POUDRE SCHOOL DISTRICT R-1
NEW FORT COLLINS HIGH SCHOOL
FORT COLLINS COLORADO

FIRST FLOOR PLAN
ADMINISTRATION
DINING & COMMONS

"E" WING UPPER LEVEL FLOOR PLAN

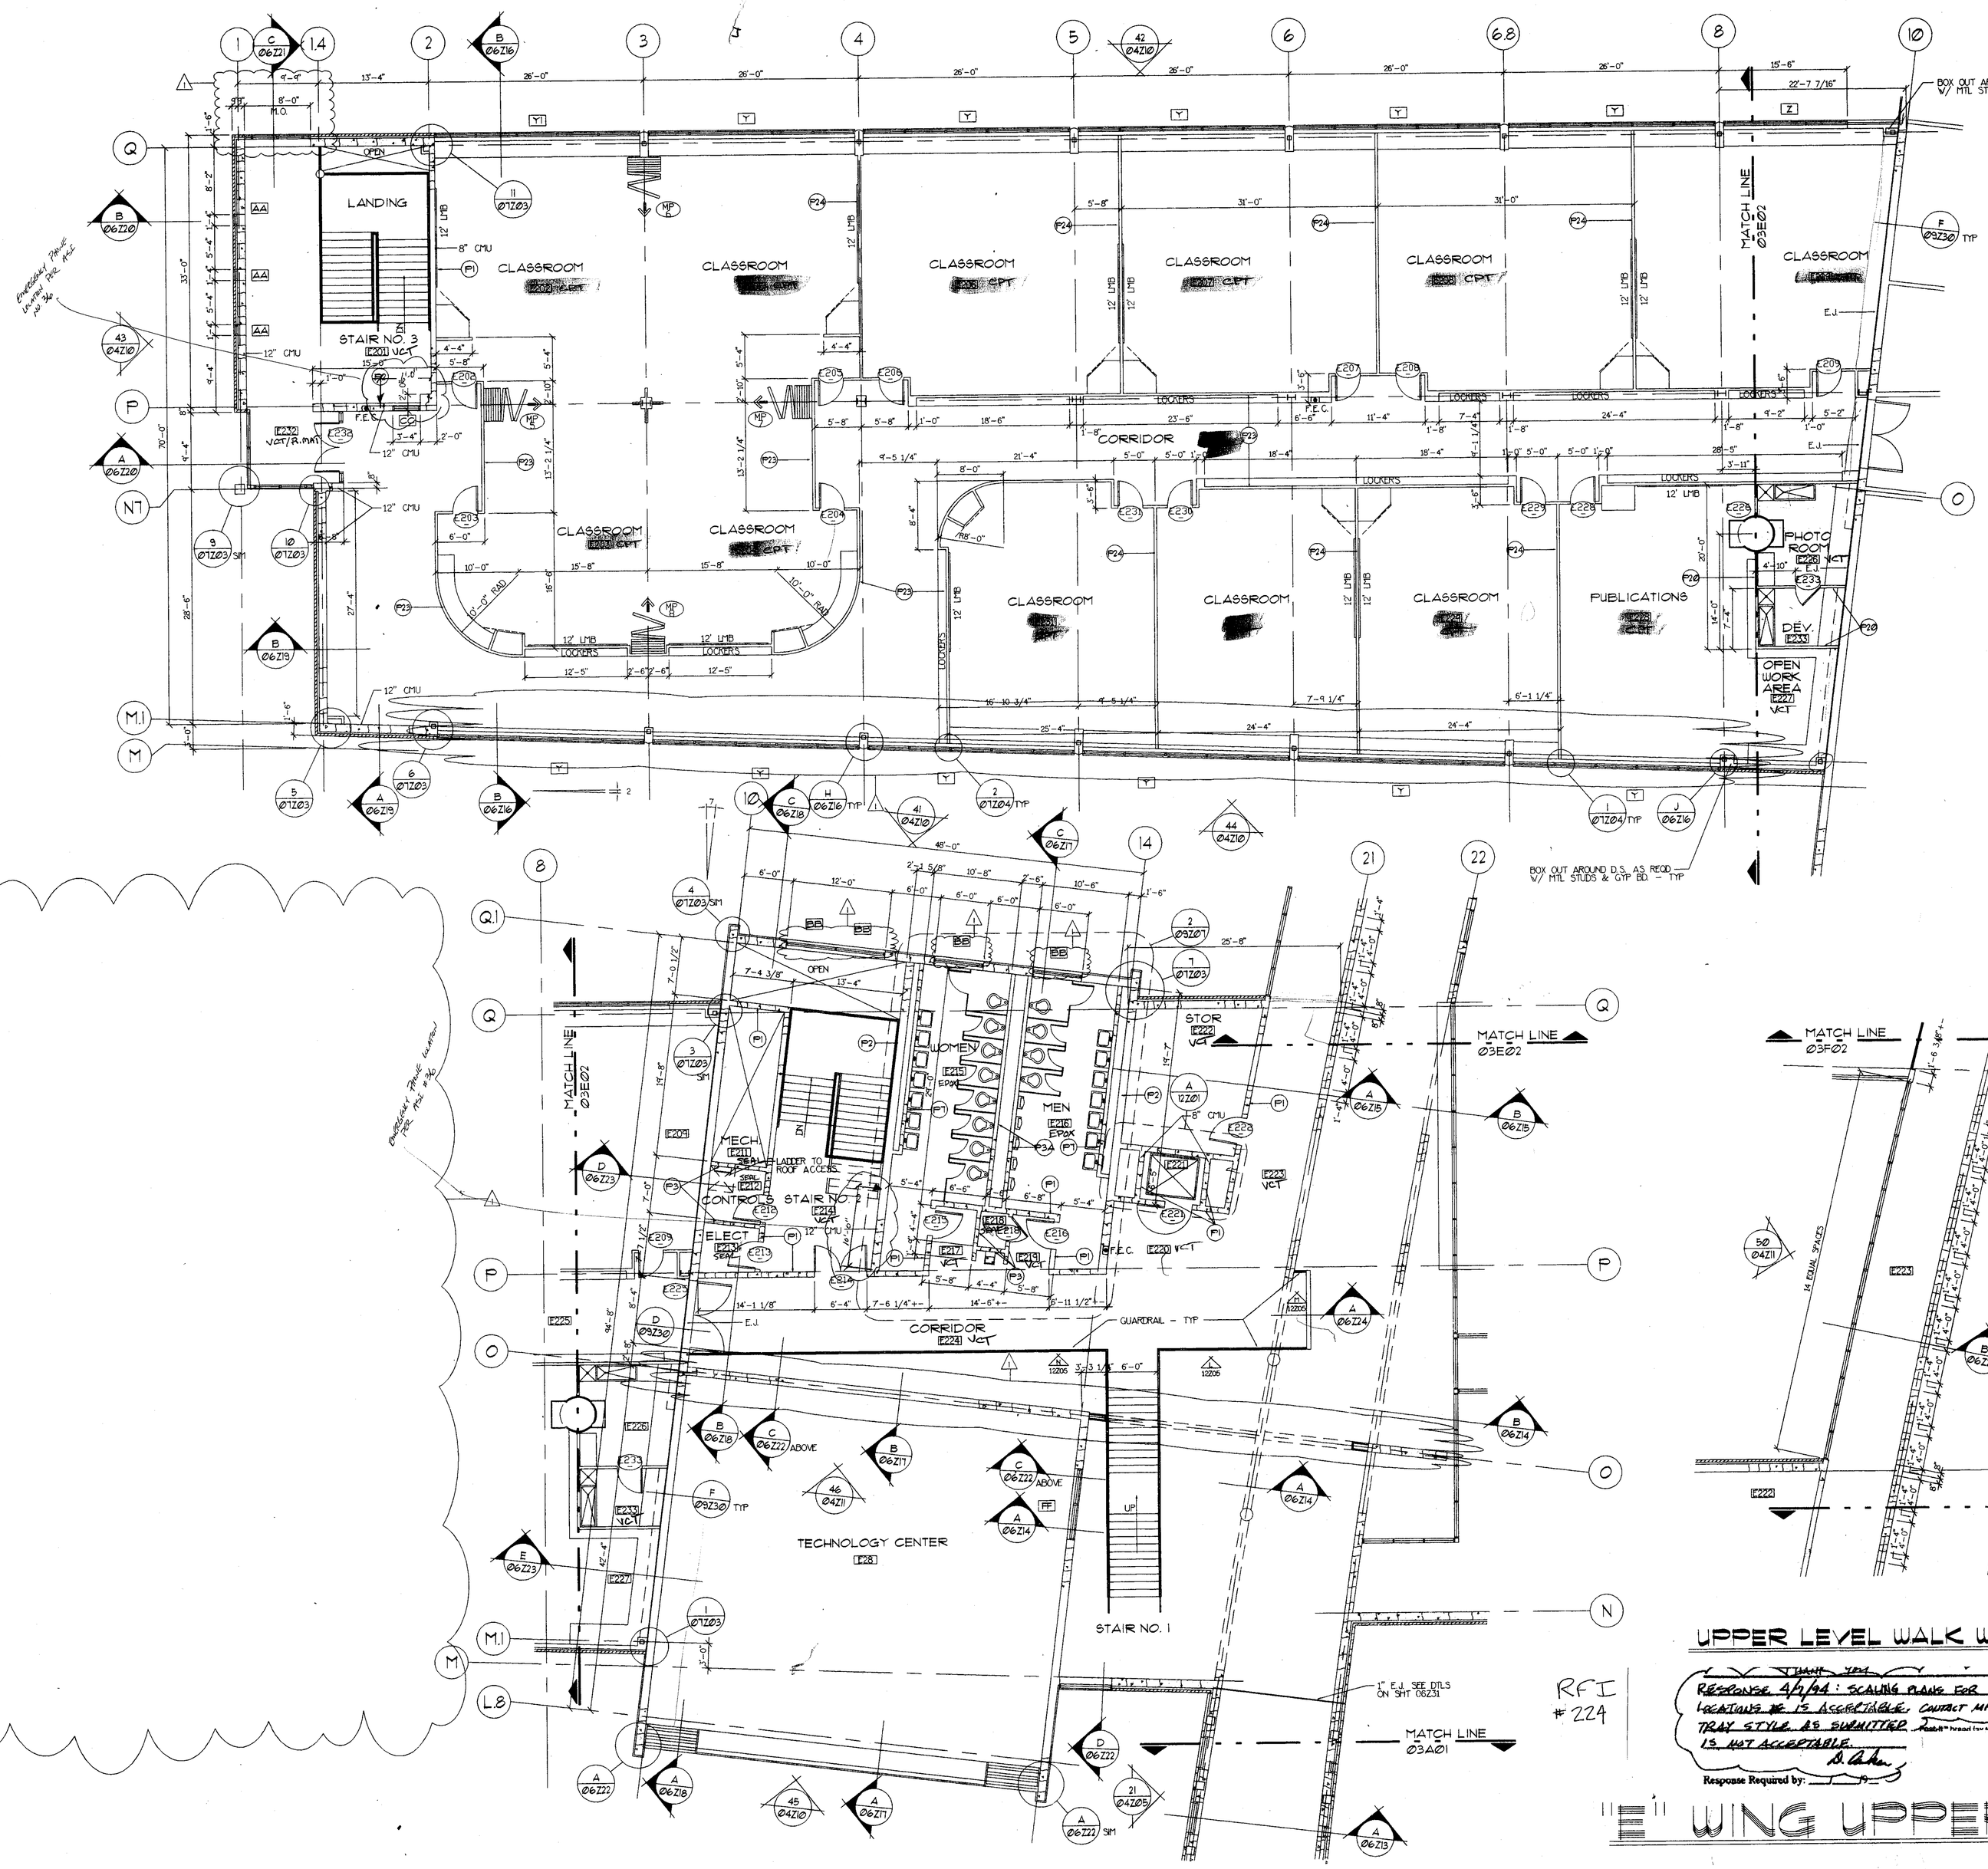
RFI #224

RESPONSE 4/7/94: SCALING PLANS FOR MARKER/TACK BOARD LOCATIONS IS ACCEPTABLE. CONTACT MFR BECAUSE CHALK TRAY STYLE AS SUBMITTED IS NOT ACCEPTABLE.

"E" WING
UPPER LEVEL FLOOR PLAN

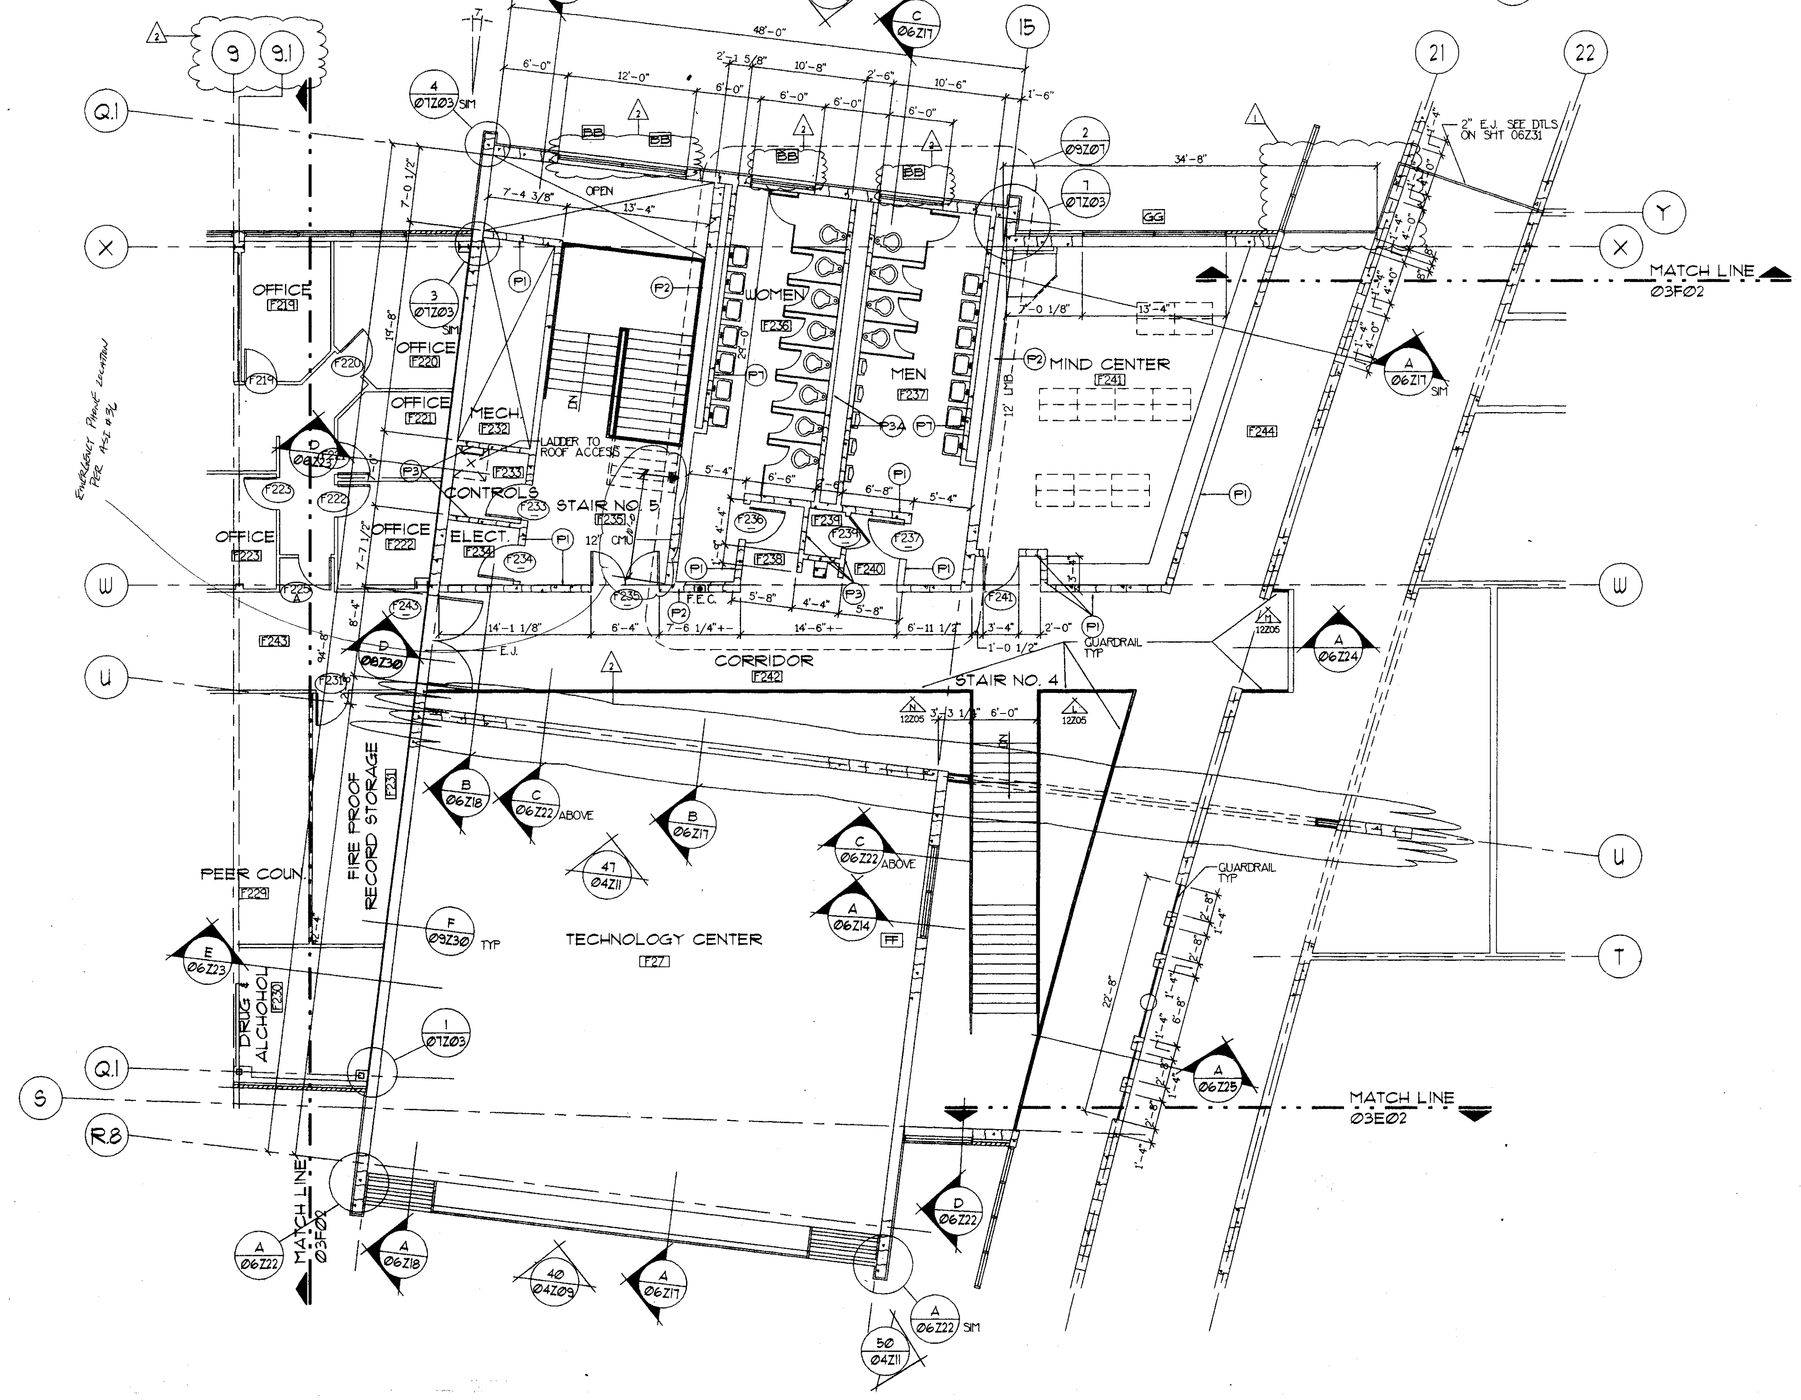
RFI #224

SHOWING FOR
RM. F 213 40% Common Ends
60% FREE STANDING
PER RFI 180
F 231 - 100% common ends

RESPONSE 4/7/94: SCALING PLANS FOR MARKER/TACK BOARD LOCATIONS IS ACCEPTABLE. CONTACT MFR BECAUSE CHALK TRAY STYLE AS SUBMITTED IS NOT ACCEPTABLE.

"G" WING
LOWER LEVEL FLOOR PLAN

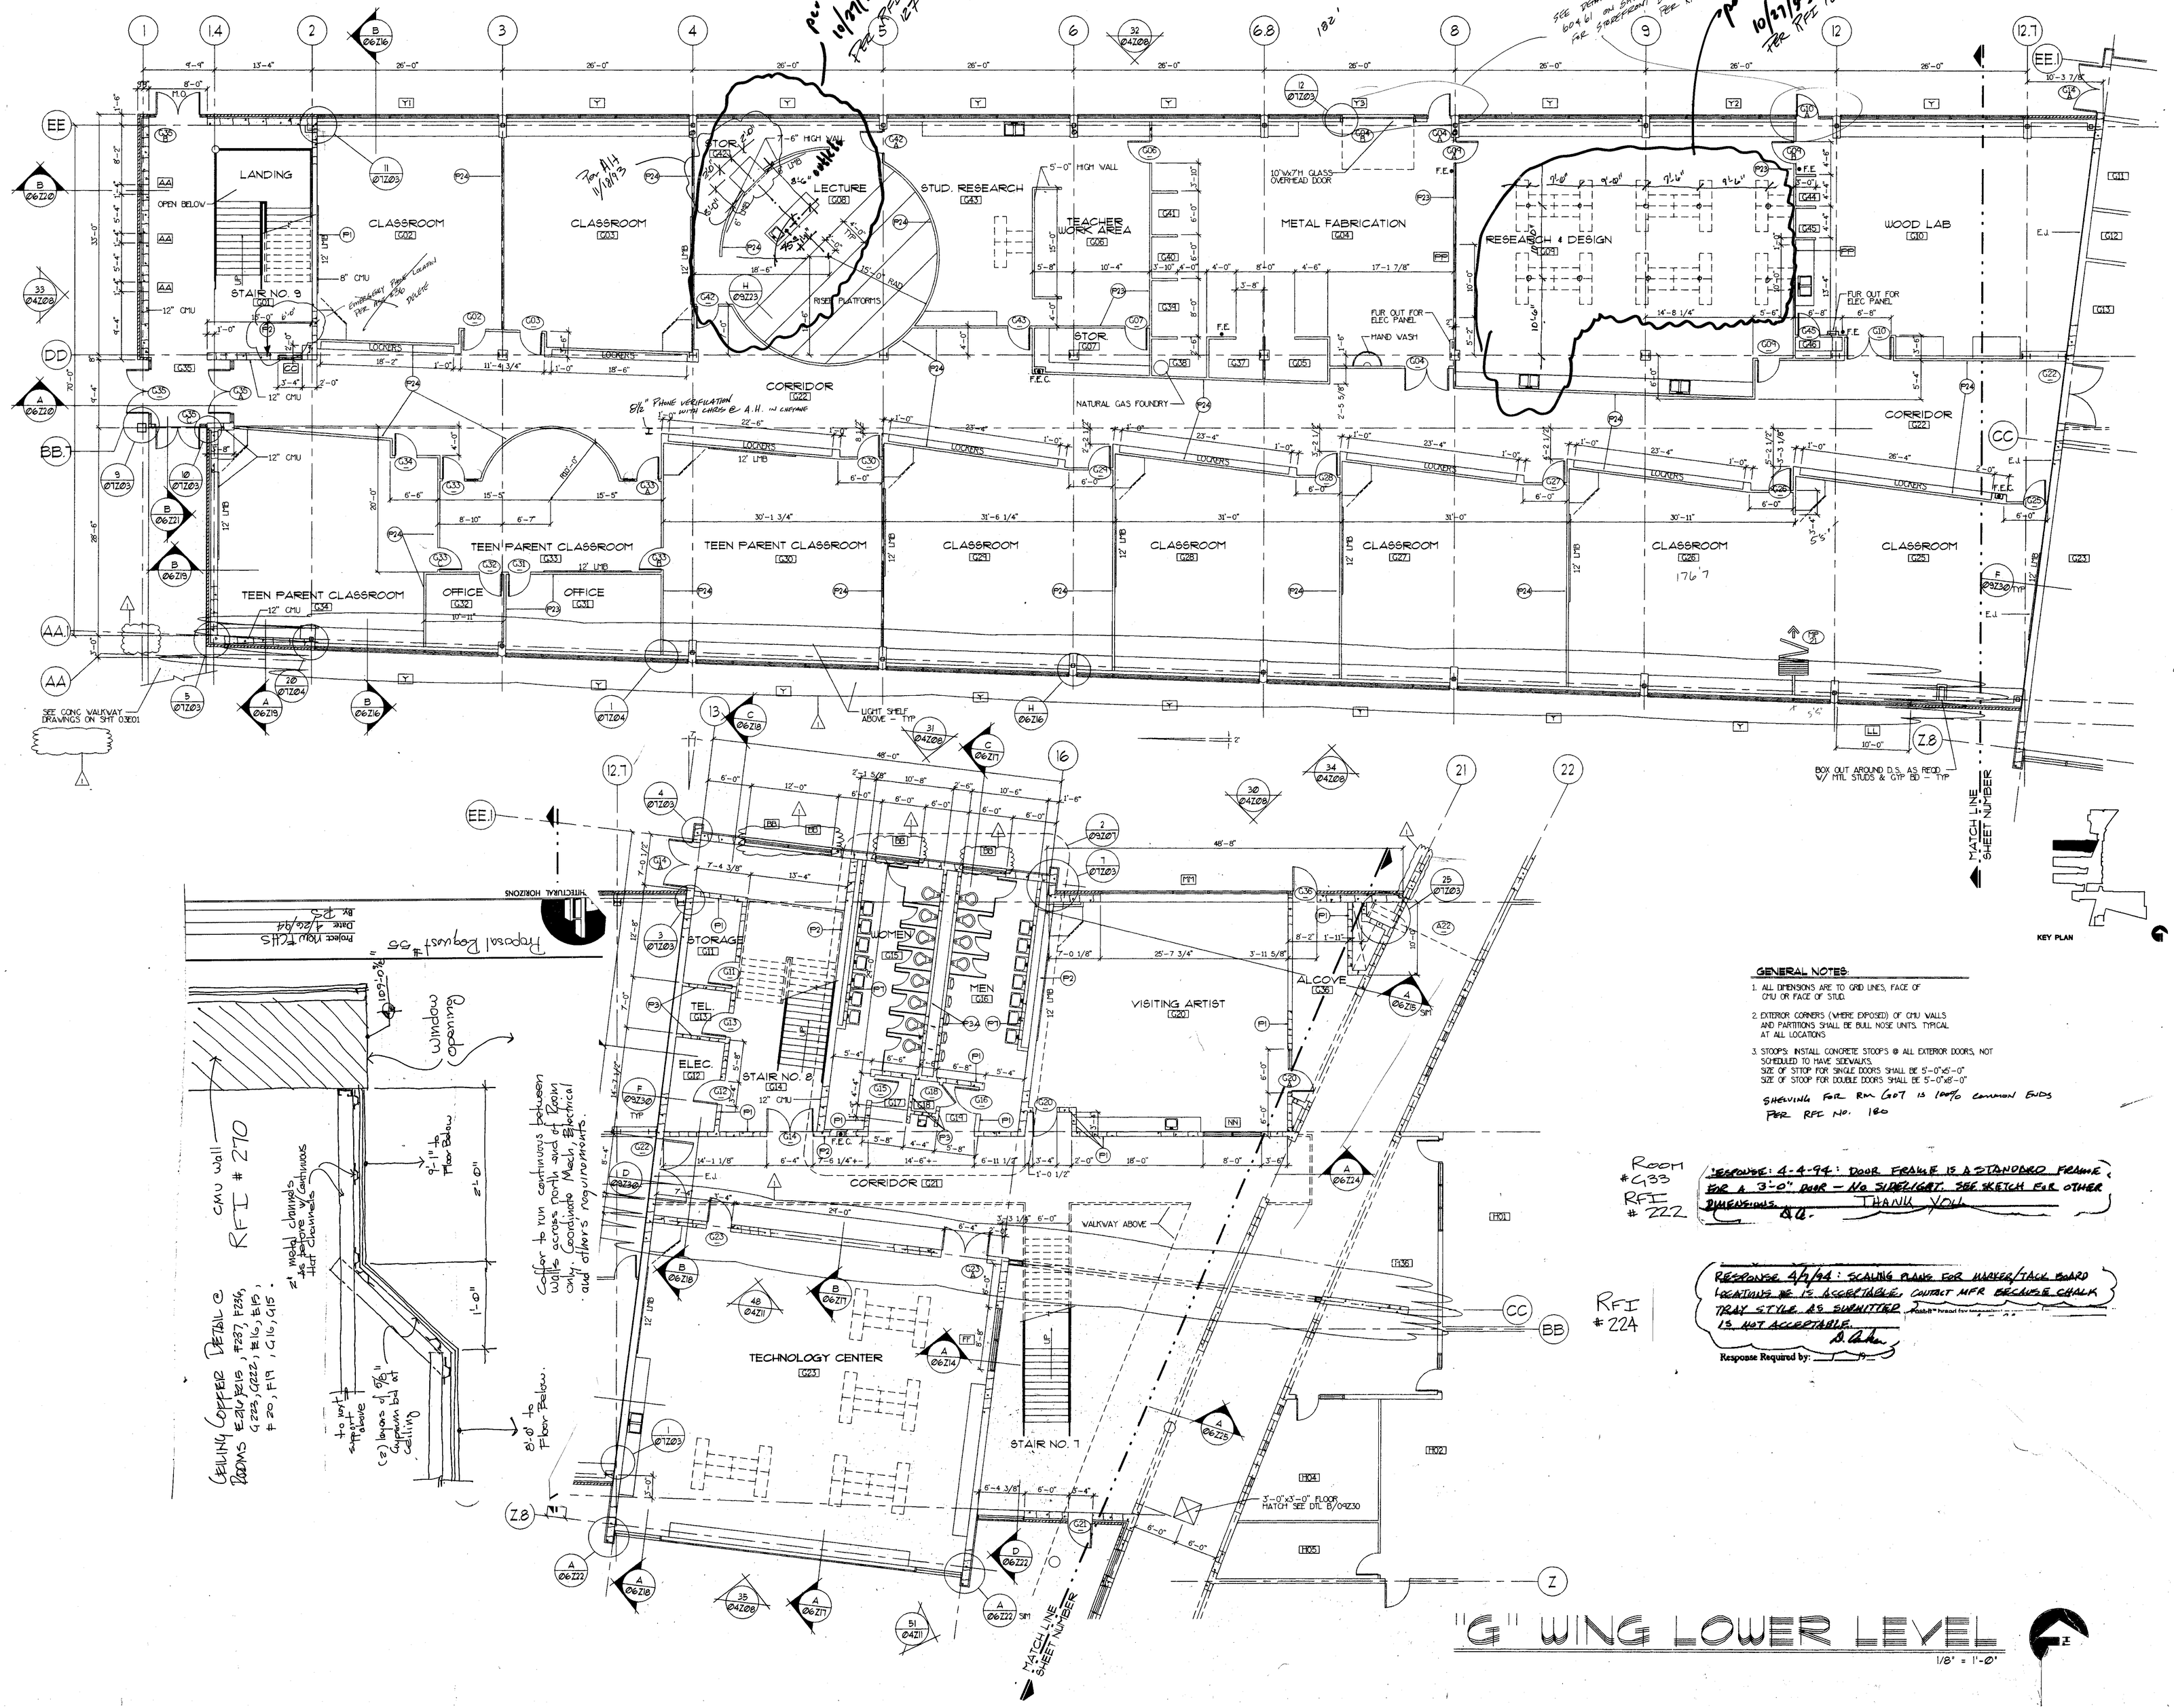
per AH 10/27/93 PER RFI 127

SEE DETAIL ELEVATIONS 604 & 61 ON SHT 1/2 & 3 FOR SUBSTANTIAL DIMENSIONS PER RFI NO. 211

SHELVING FOR RM G07 IS 100% COMMON ENDS PER RFI NO. 180
